**Rezoning Transportation Analysis**  
**Petition Number: Insert Zoning Petition #2021-062**  
*General Location Identifier: 14303106*

**Revision Log:**

Date	Description
05-27-2021	First Review (KP)

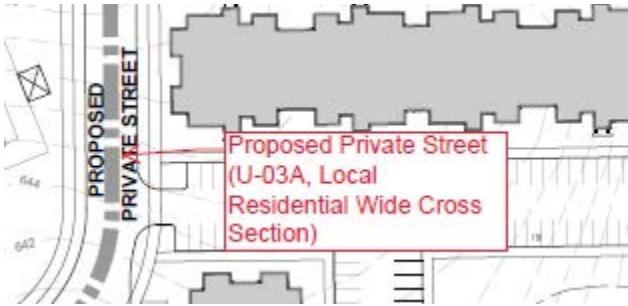
3. Revise site plan and conditional note(s) by clarifying the cross section associated with the private street. If the proposed private street is intended to be constructed in accordance with the Local Residential Wide Section, then the site plan needs to clearly label the private street as such.

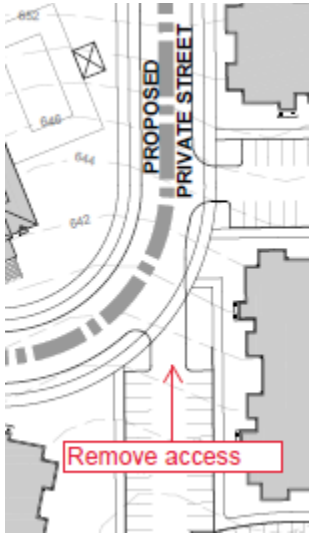
- 4. Revise the site plan and conditional notes by removing the parking lot access driveway located in the curve of the private street.

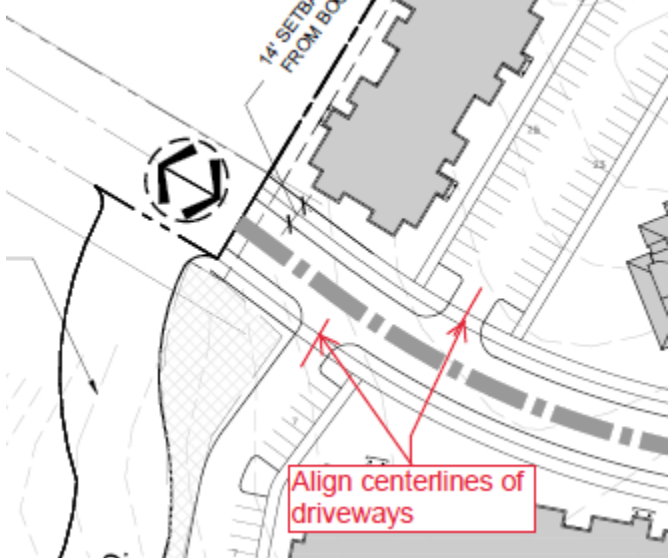
- 5. Revise the site plan by aligning the centerlines of the driveways closest to the existing Cascade Pointe Boulevard street stub. This will mitigate the points of conflict along this proposed private street.

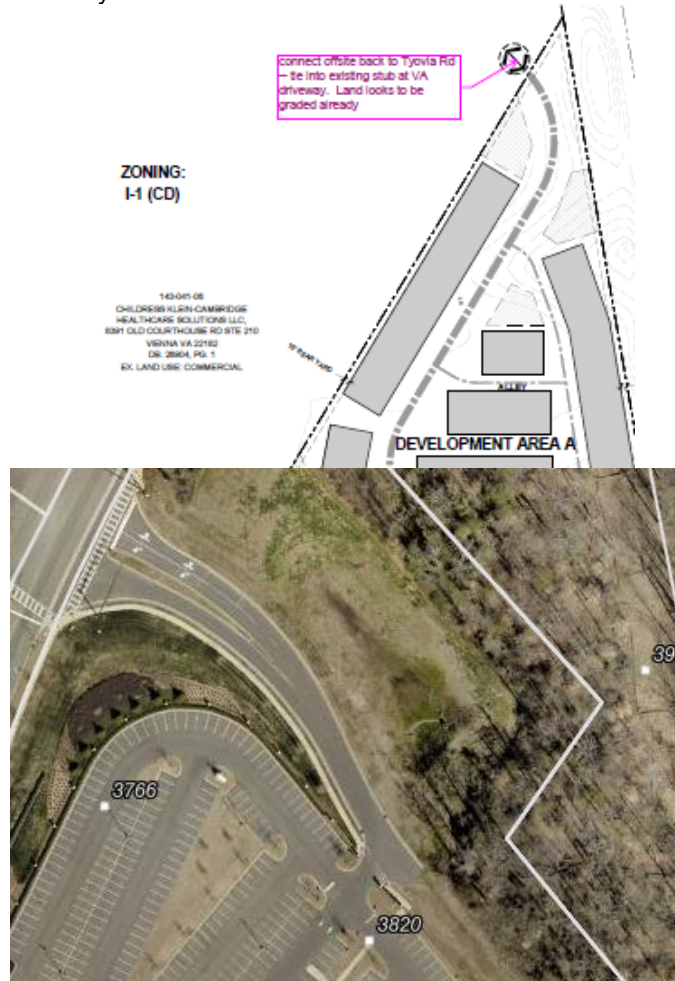
- 6. Revise the site plan and conditional notes by committing to connect to the northern site access into the existing stub adjacent to the VA Health Clinic, located on PID 14304106. The cross section and relative infrastructure should be clearly labeled and dimensioned.

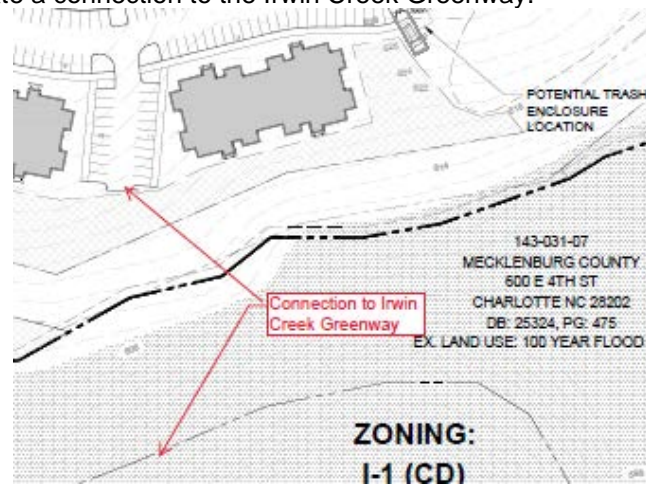
- 7. Revise the site plan and conditional notes by committing to coordinate with Mecklenburg County Parks and Recreation to create a connection to the Irwin Creek Greenway.
